RIDGWAY PLANNING COMMISSION

REGULAR MEETING AGENDA

Tuesday, October 26, 2021

To: Town of Ridgway Planning Commission
Cc: Preston Neill, *Ridgway Town Manager*
From: TJ Dlubac, AICP, *Community Planning Strategies, Contracted Town Planner*
Date: October 21, 2021
Subject: McIsaac Subdivision Planned Unit Development Preliminary Plan and Plat for October 26th PC Meeting

ROOF PLAN

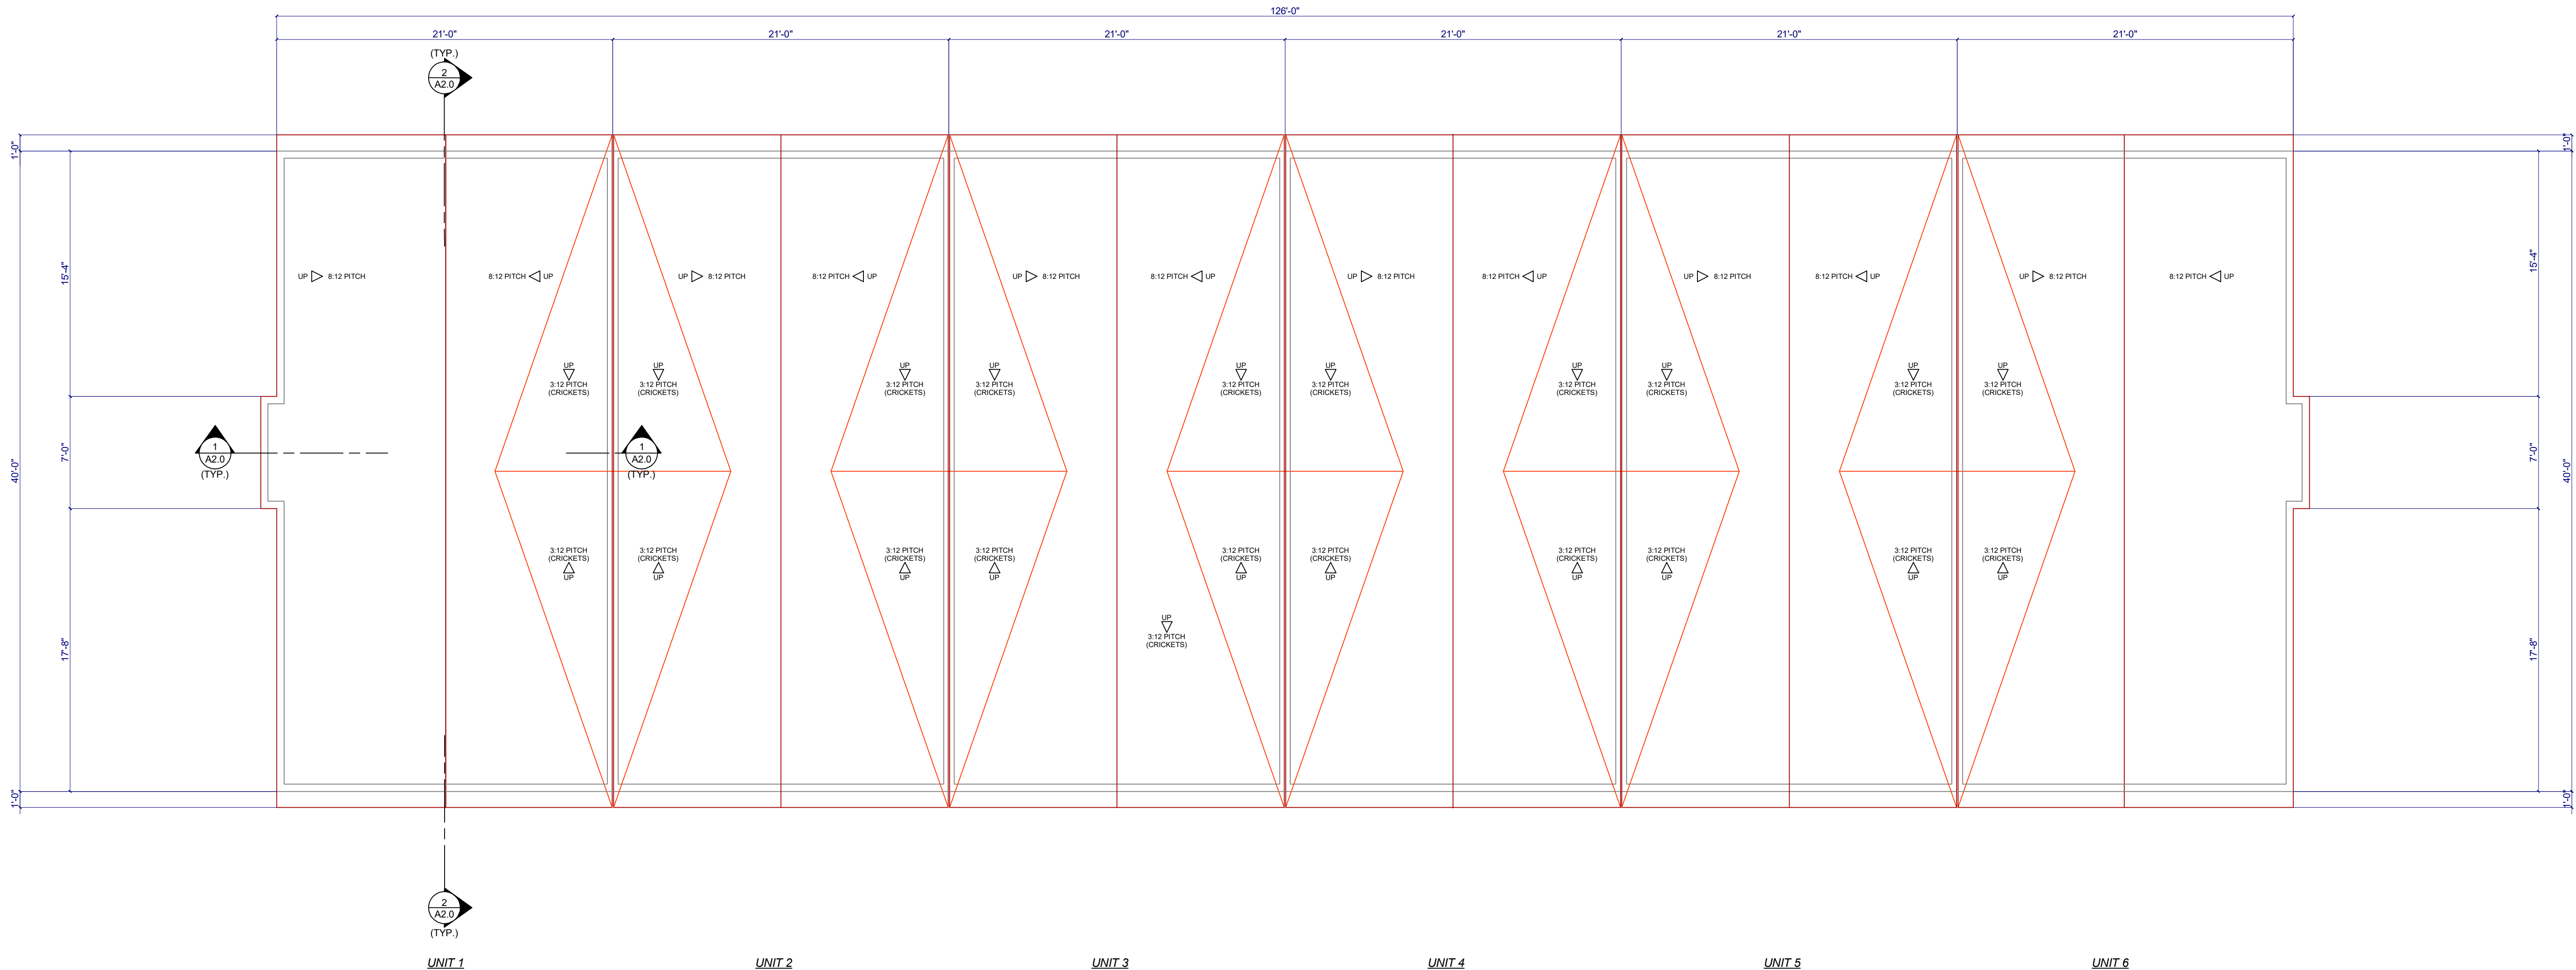
26. July 1 Comment: The roof plan (Sheet A1.0) indicates there are roof overhangs on all sides of the building. However, those overhangs are not indicated, depicted, nor dimensioned on the elevations provided (Sheet A0.0 and A0.1). Please update plan sets to be consistent amongst themselves.

26. RE: Roof overhangs. The roofing plan is correct and shows no overhangs on the east and west, and a 12" "pop out" detail on the north and south (front & back). I have added dimensions to A1.0 (Roof Plan) to make this more clear.

CURB & GUTTER PLAN & PROFILE
C4.0

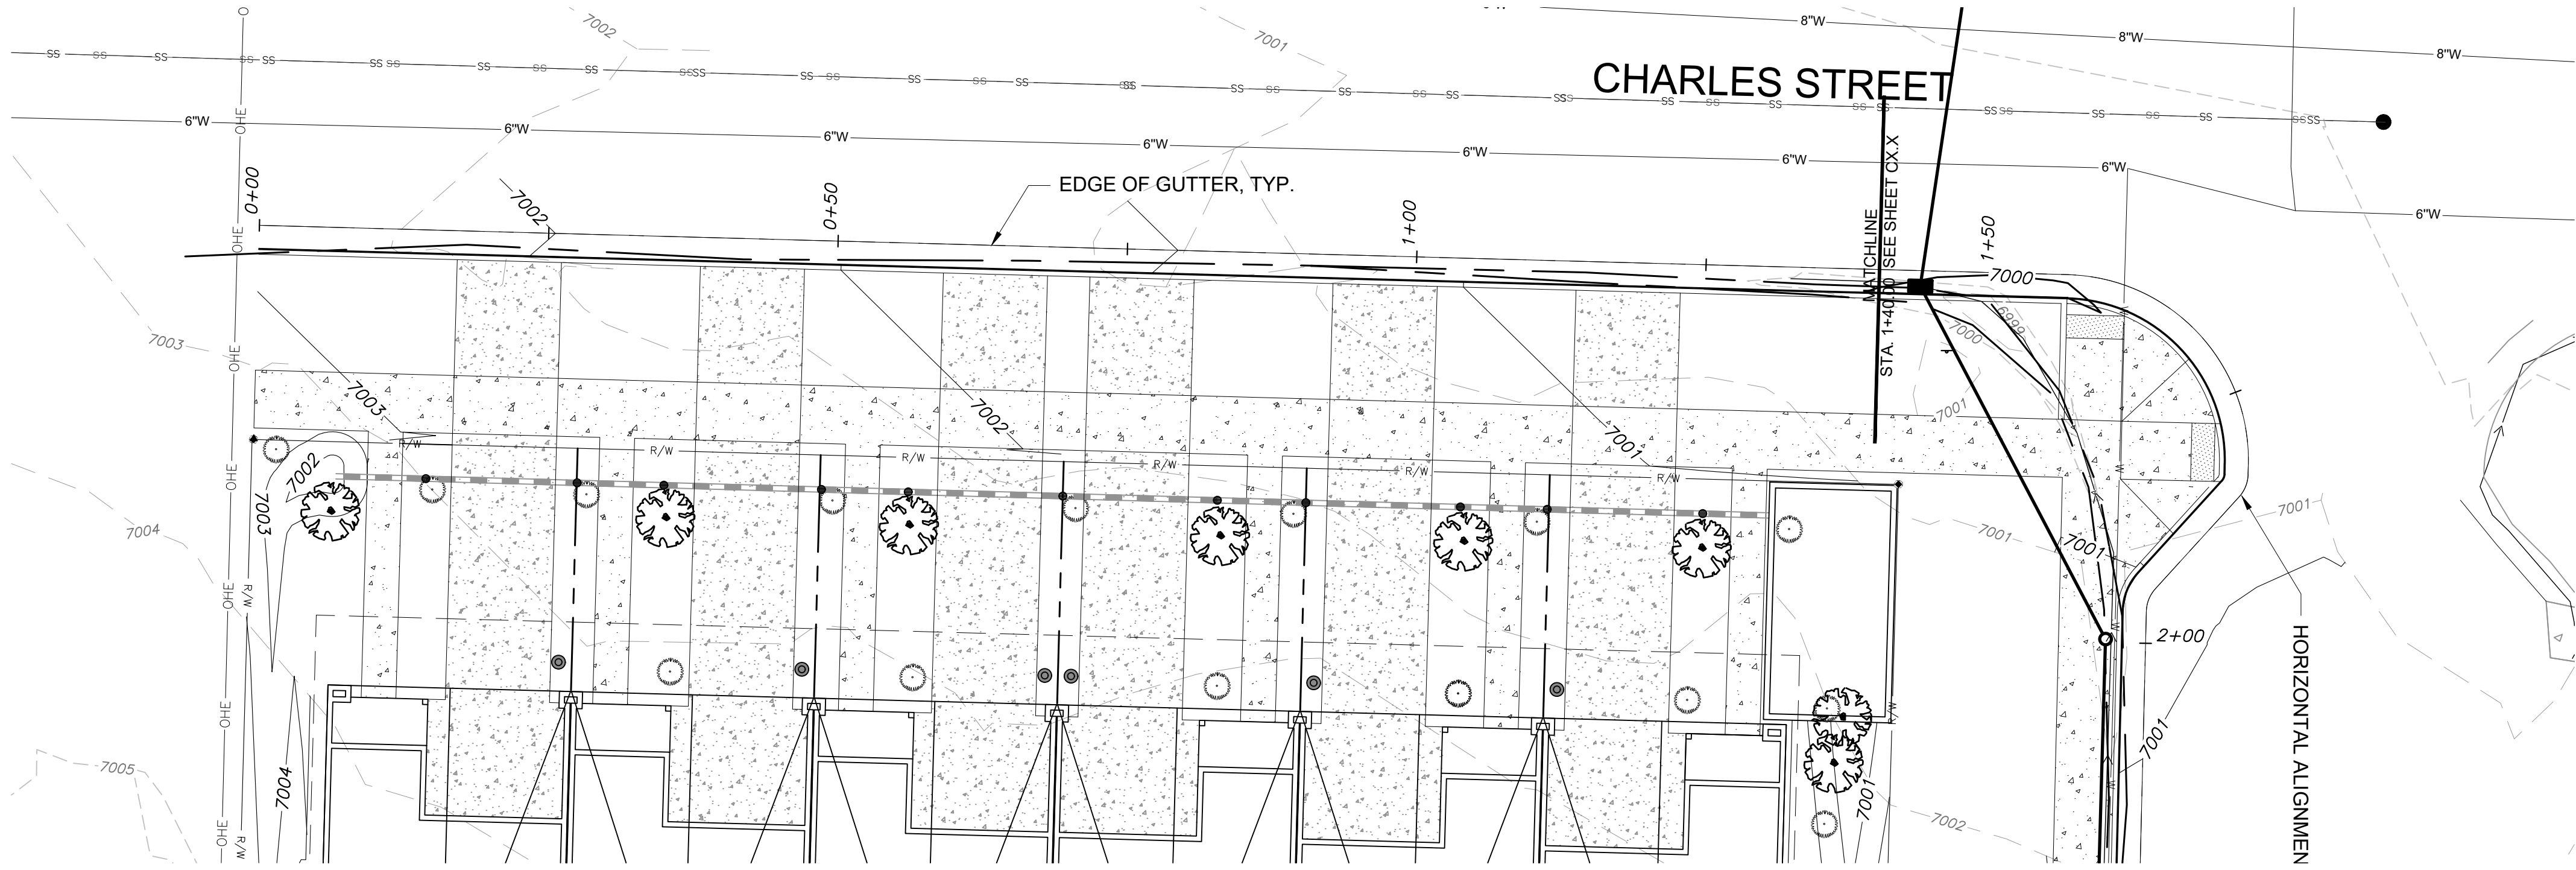
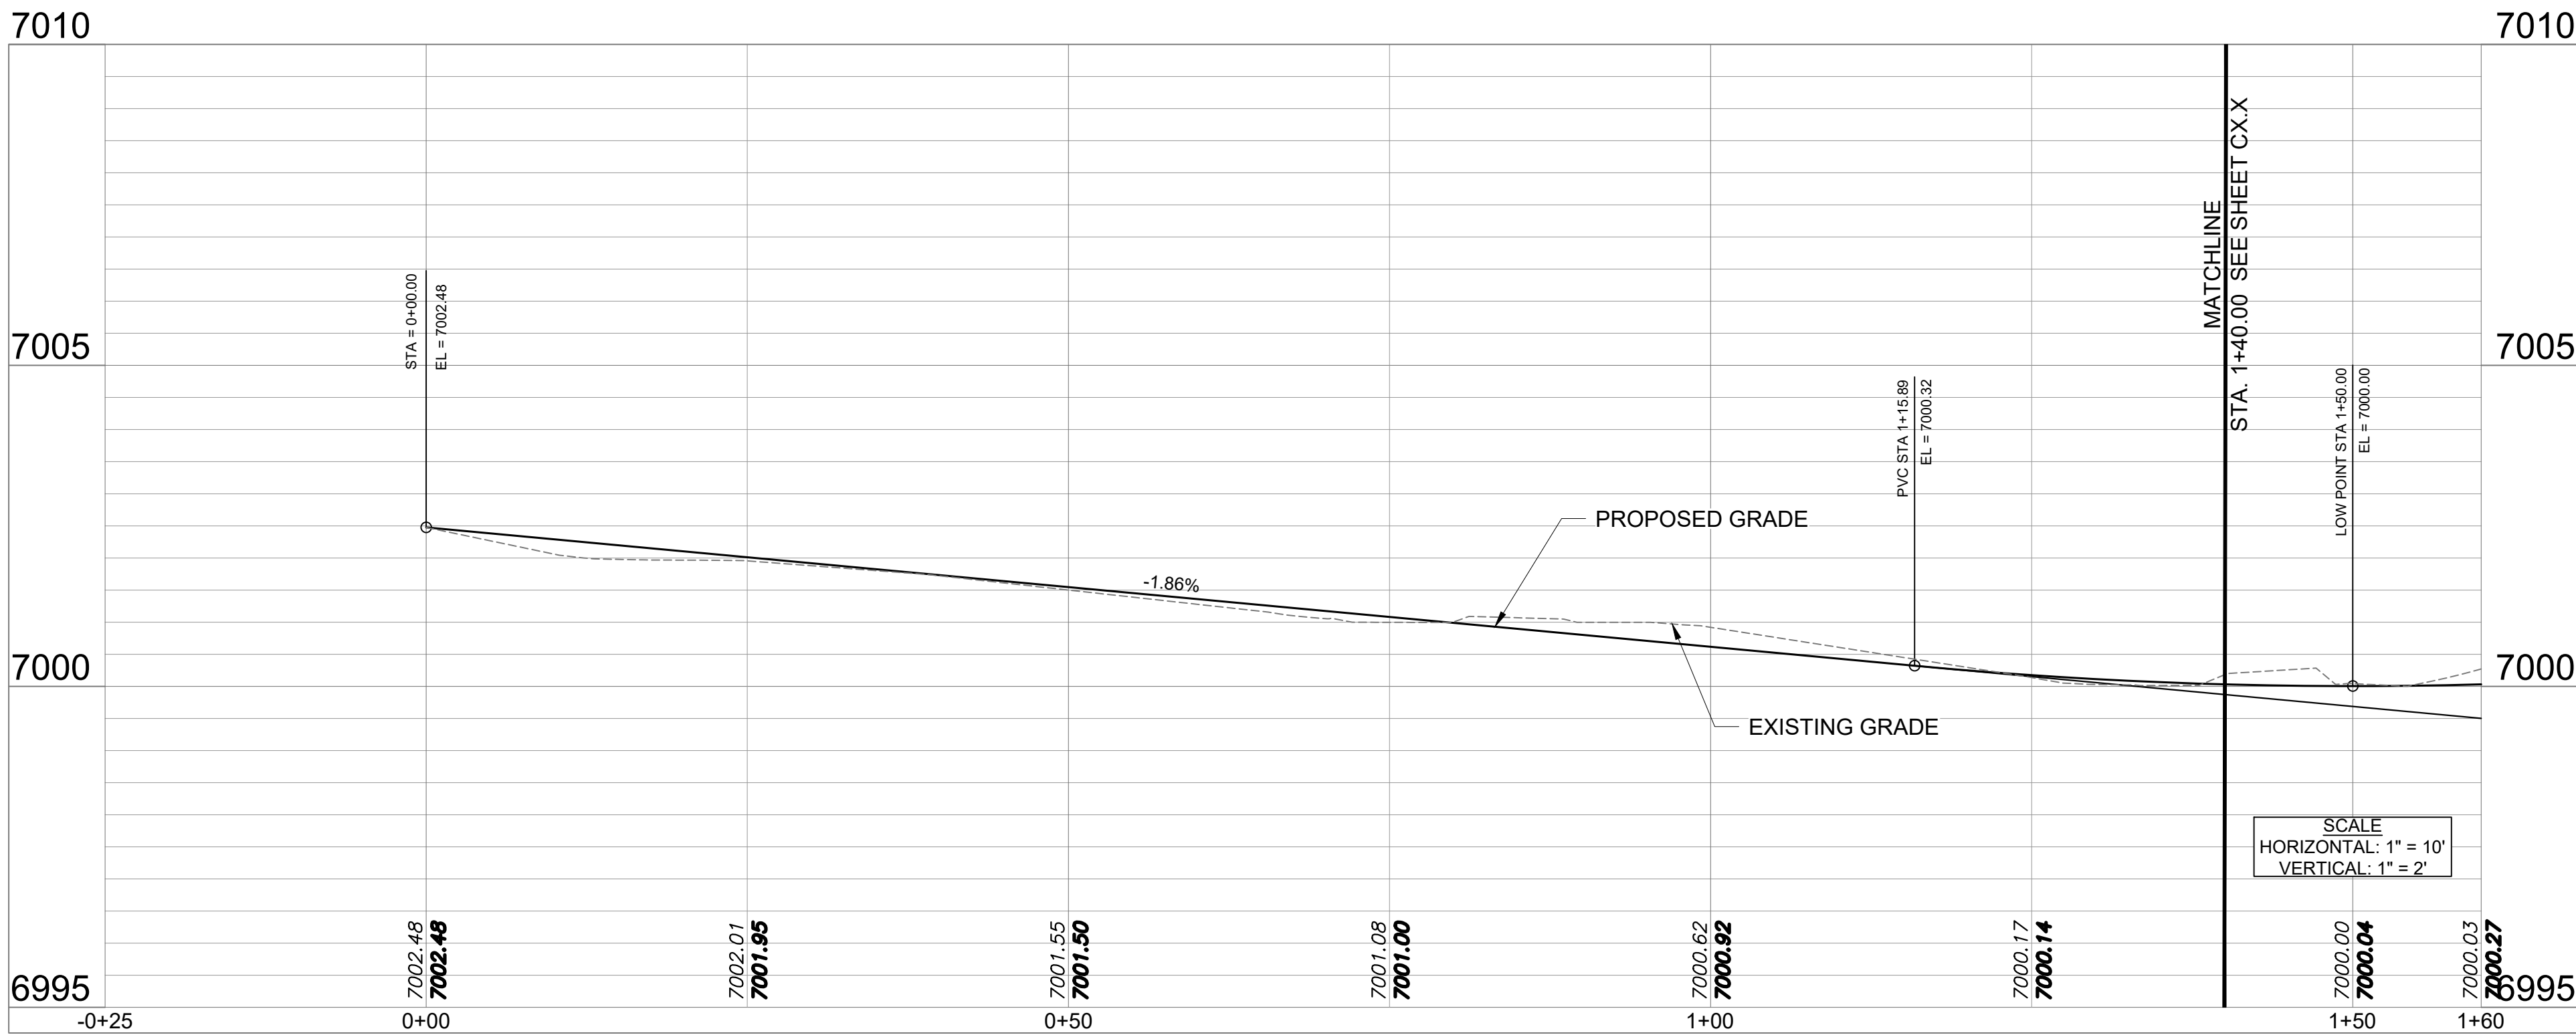
C4.0, 4.1			The profile on Charles should follow the C&G around the bulb out and likely needs coordinates and elevations are key points.	Not addressed	Horizontal alignment does follow the bulb. Call out added on sheet C4.2	
			We compared the slopes on Cora from the alley to Charles with the design drawings we shared with the developer and the developer's plans have flatter slopes. Please explain the differences.	Not addressed	Topo is based off of two separate surveys. Both showing approximately the same slopes.

C4.0, 4.1	profile					The profiles show several areas where the difference between existing and proposed grade is more than a couple of inches. We need cross sections for those areas. Where you are proposing to cut into the existing road you will need to rebuild the road structure. Where you are filling, please be sure there will still be 2-3% slope on the road from crown to gutter face. These should be visible from the cross sections. You might want to modify the profile to more closely follow existing grade to avoid the need to rebuild so much of the road.						
C4.0, 4.1	profile					The low point is shown at 1+50 but the inlet is shown at ~1+45. The good news is that it looks like the inlet can be moved to 1+50 and not interfere with the ADA ramp even if the sidewalk
